**PLANNING COMMISSION SITE PLAN REVIEW SHEET
CONDITIONAL USE SITE PLAN APPROVAL**

CASE NUMBER: SPC-02-0034C(R2) **PC DATE:** January 22nd, 2019

PROJECT NAME: Town Lake Park Cultural Landscape Phase Two

OVERALL
SITE PLAN

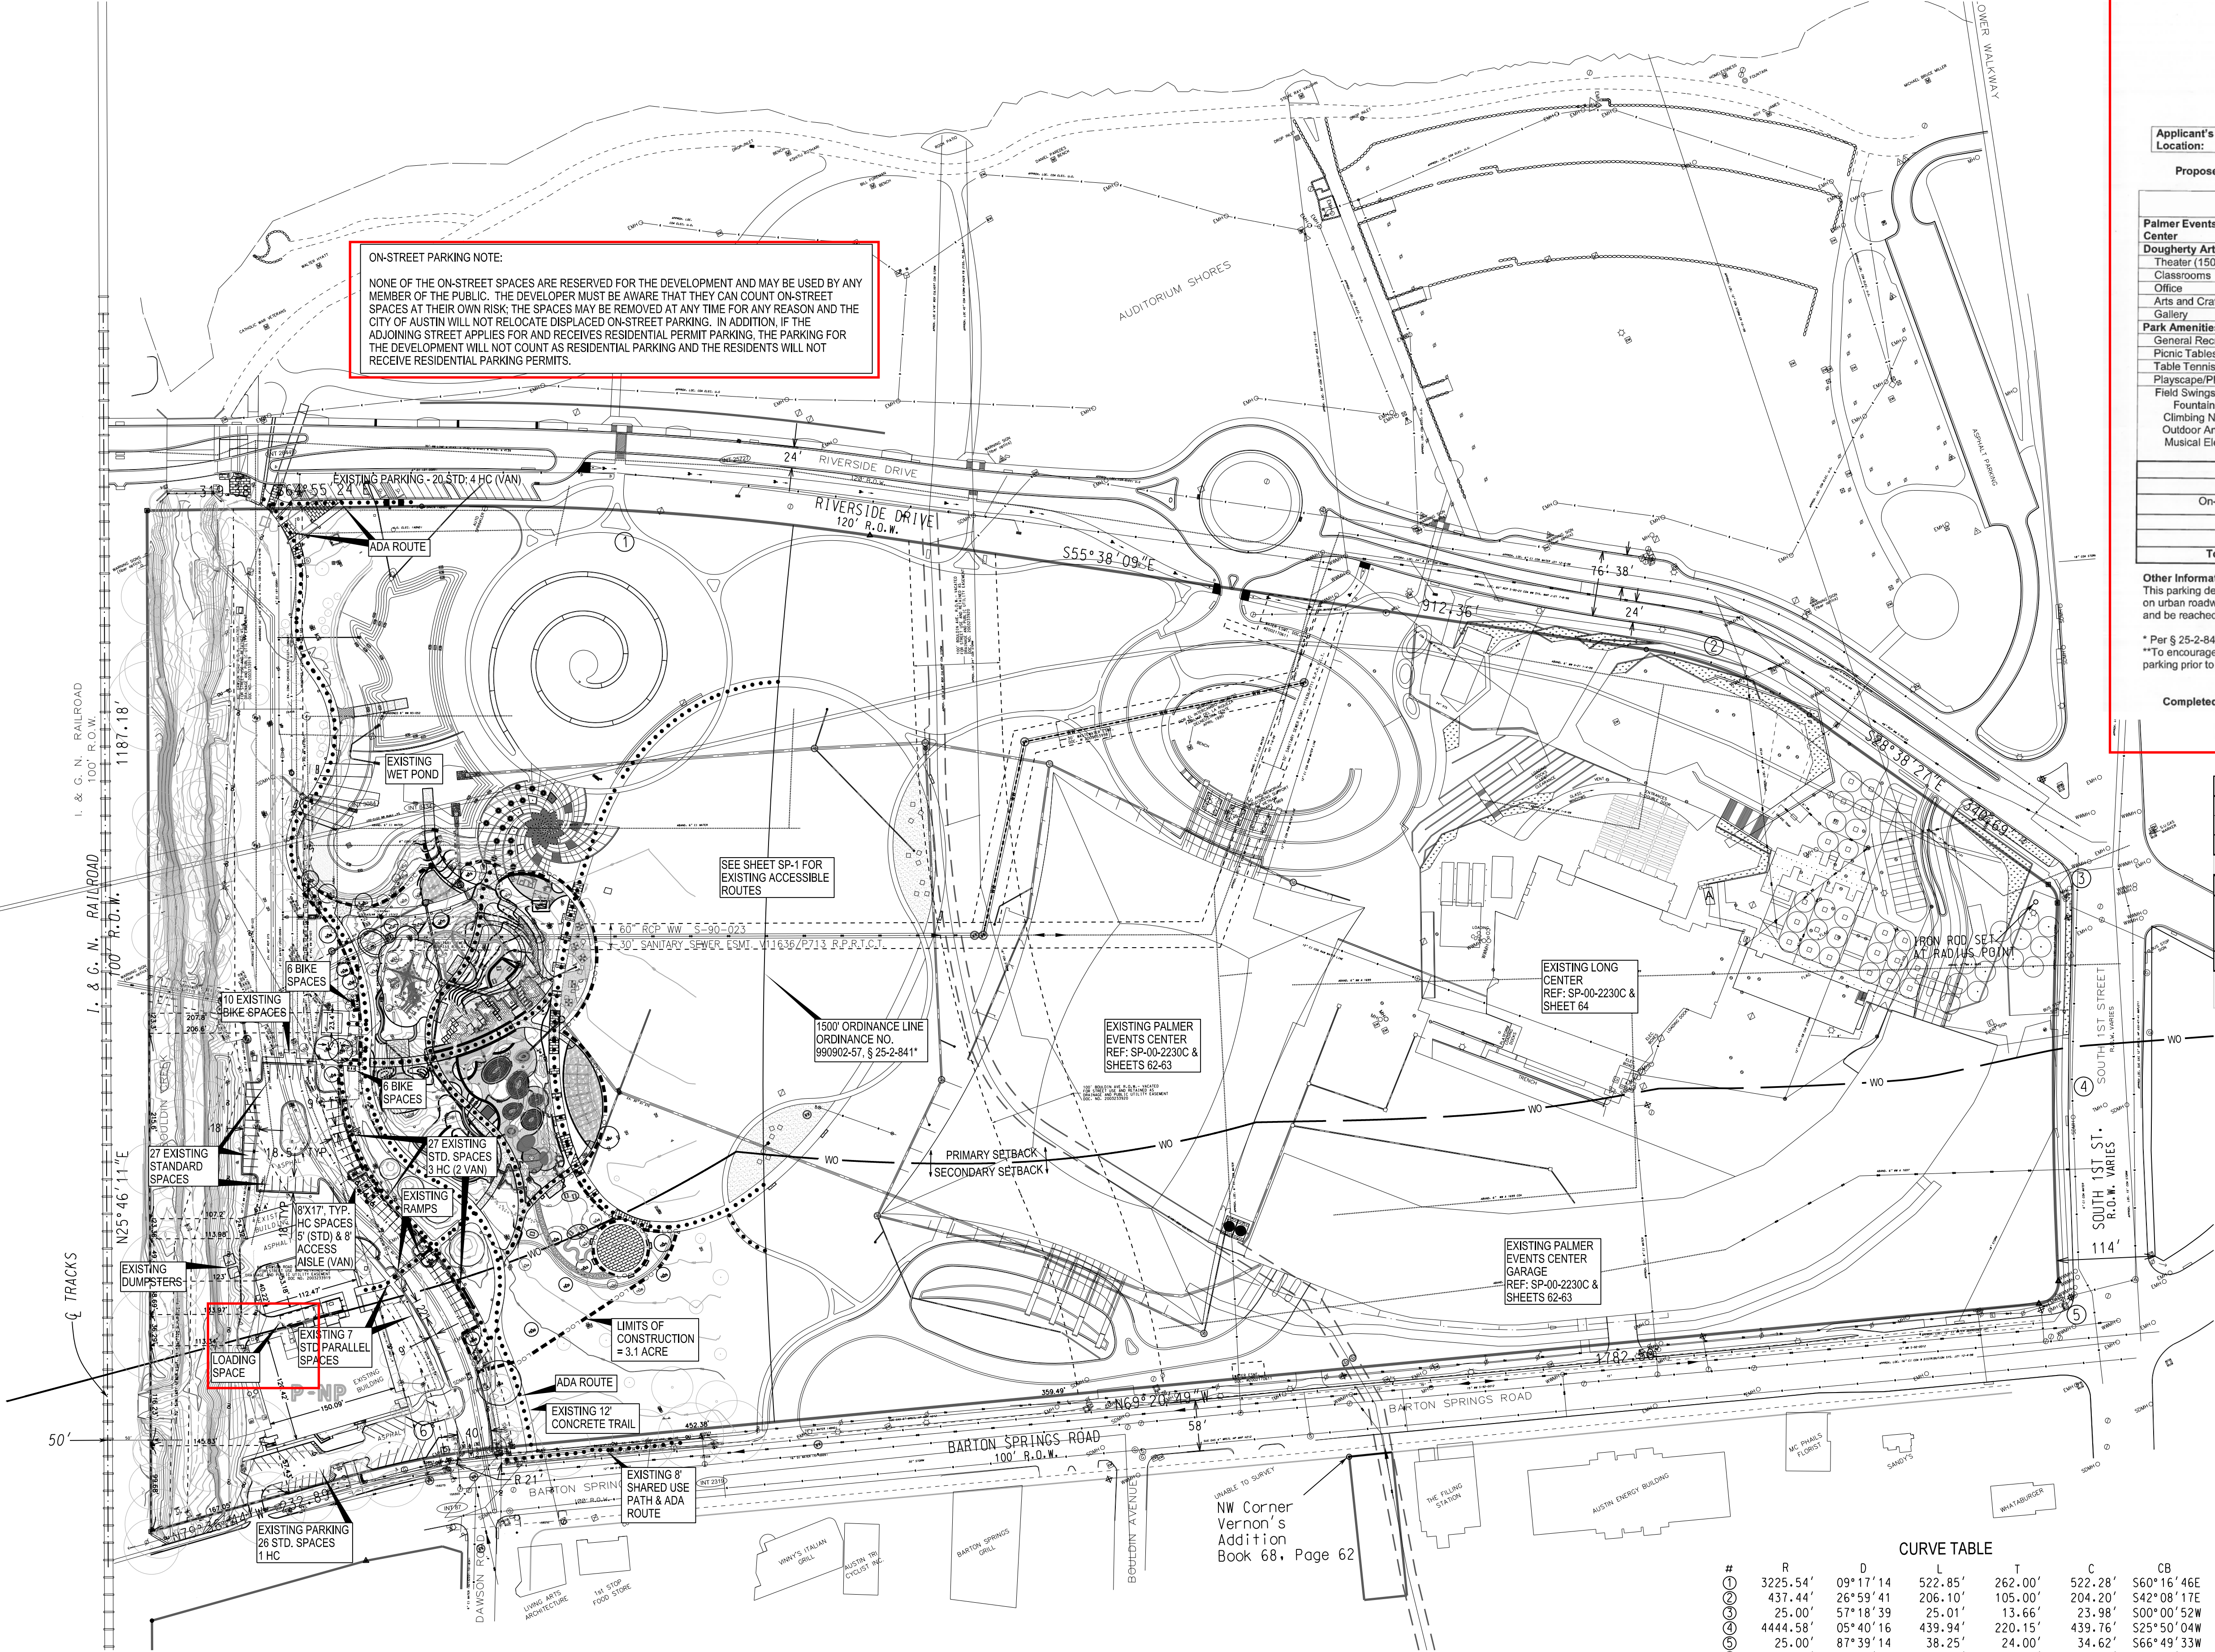
Staff recommends approval of the improvements shown on the site plan. The related site plan has been reviewed in accordance with all requirements of the Land Development Code once submitted.

- 1. Comply with the requirements of this title;** Staff Response: This site plan complies with all regulations and requirements of the Land Development Code.

- 2. Comply with the objectives and purposes of the zoning district;** Staff Response: The proposed use is compatible with the abutting uses.
- 3. Have building height, bulk, scale, setback, open space, landscaping, drainage, access, traffic circulation, and use that is compatible with the use of an abutting site;** Staff Response: The site plan has complied with the Land Development Code.

- 4. Provide adequate and convenient off-street parking and loading facilities; and** Staff Response: These items have been reviewed and approved by the appropriate reviewer.

- 5. Reasonably protect persons and property from erosion, flood, fire, noise, glare, and similar adverse effects.** Staff Response: These items have been reviewed and approved by the appropriate reviewers.
